Keithley Instruments
28775 Aurora Road
Cleveland, Ohio 44139
1-800-833-9200
tek.com/keithley

This firmware is used on the following Keithley Instruments product models:

Model 2450 Interactive SourceMeter® Instrument, 2450-NFP, 2450-RACK, 2450-NFP-RACK

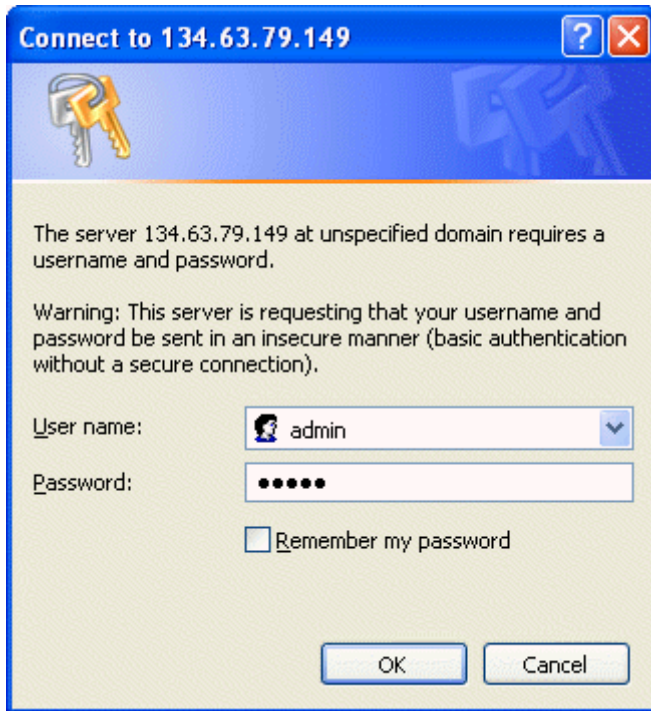
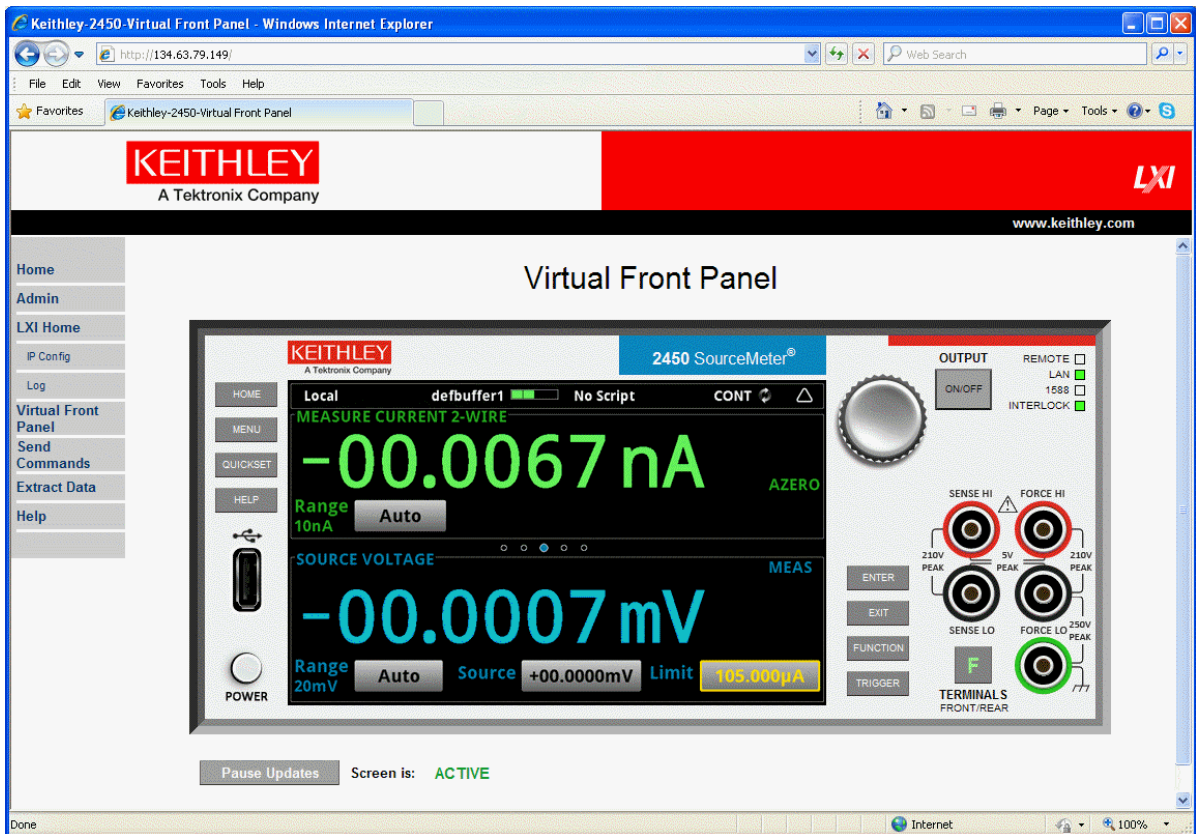
Implement new Virtual Front Panel capability.

To access the new Virtual Front Panel, access the 2450 through Ethernet using your favorite Internet browser.

When asked for a Username and Password: enter the Username and Password for that particular 2450. The default Username is `admin` and the default Password is `admin`.

An example of the 2450 Virtual Front Panel is shown below. Users can use their mouse from a standard PC to control the instrument. Users can also use touch screens from most touch screen devices that can access the 2450 IP address.

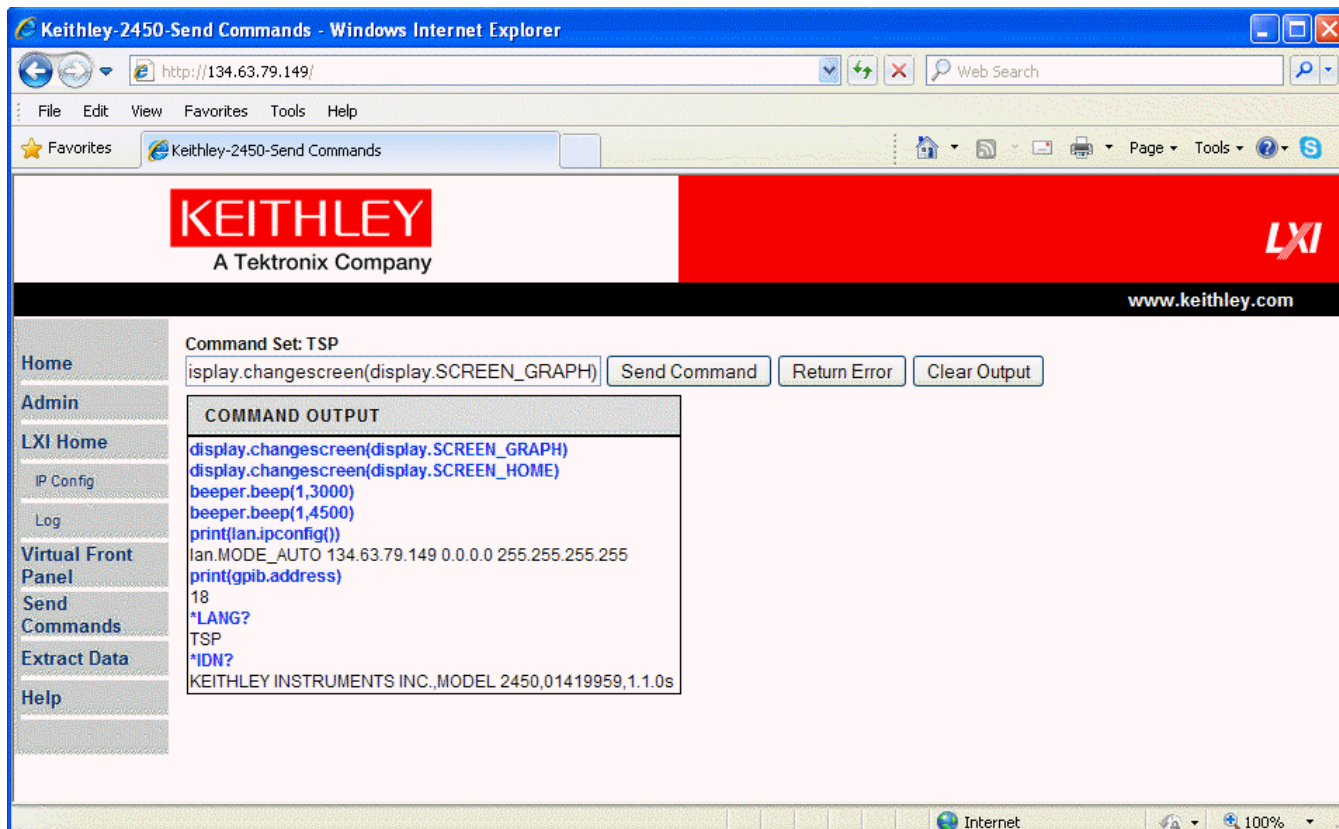
Enhancement:

The behavior of the *LANG? command on the 2450 has been changed as follows.

Sending the query *LANG? over a non-controlling interface will no longer change the interface control of the unit. For example, if the unit is under local control, then sending the *LANG? over Telnet, USB, or GPIB will leave the unit under local control. This was done in order for KickStart (or any other remote control software) to query connected/accessible instruments without resetting them or changing or disturbing the current trigger model.

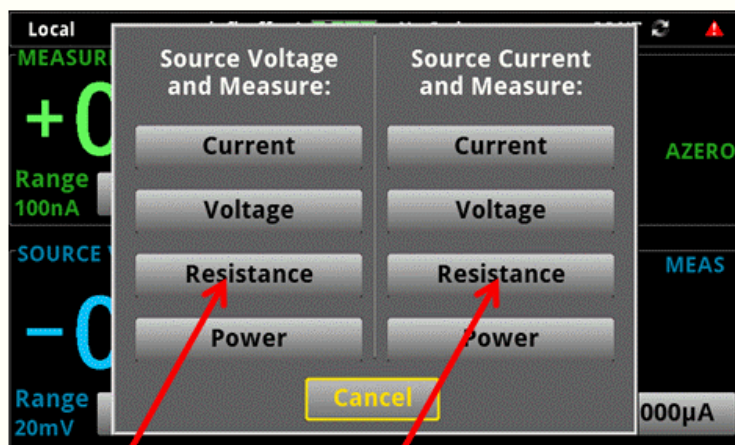
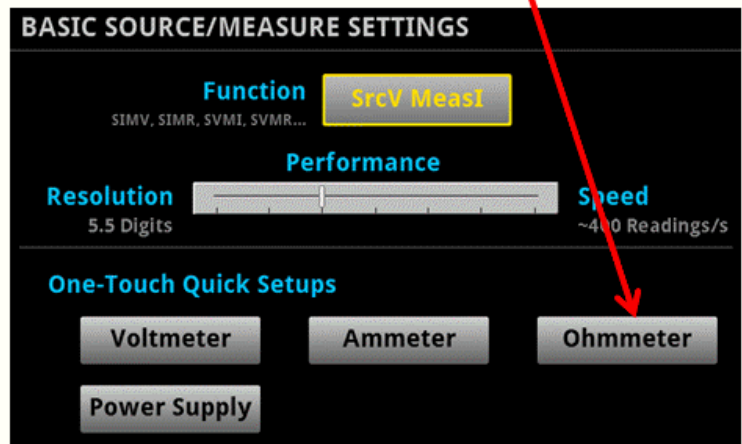
- g. New SCPI Command Usage:
 - i. "Manual Ohms" (see definition above)
 - SOURce:FUNC VOLTage
 - [SENSe[1]]:FUNC "CURRent"
 - [SENSe[1]]:CURRent:UNIT OHMOR
 - SOURce:FUNC CURRent
 - [SENSe[1]]:FUNC "VOLTage"
 - [SENSe[1]]:VOLTage:UNIT OHM
 - ii. "Auto Ohms" (see definition above)
 - [SENSe[1]]:FUNC "RESistance"
- h. Front panel user interface setting of Manual vs. Auto Ohms measurements
<see the following figure for details>

SVMI (Ω) SIMV (Ω)

Both exhibit "Manual" Ohms behavior (works just like Power by setting units to Ohms and going to SVMI or SIMV)

Exhibits "Auto" Ohms behavior

SVMR
